Change of Knurled Mounting Nut

All bushing mount **YB Series** illuminated pushbuttons and indicators (including custom products).
All square **YB2 Series** illuminated pushbuttons (including custom products).

Change of Knurled Mounting Nut	
Before Change	After Change
 <p>Material: PBT</p>	 <p>Material: Fiber Reinforced PBT</p>

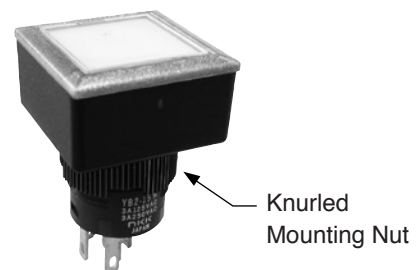
The height and material of the knurled mounting nut will change.

- No change in panel thickness, cutout, or mounting torque.
- AT106 socket wrench can still be used.
- Contact factory for further details.
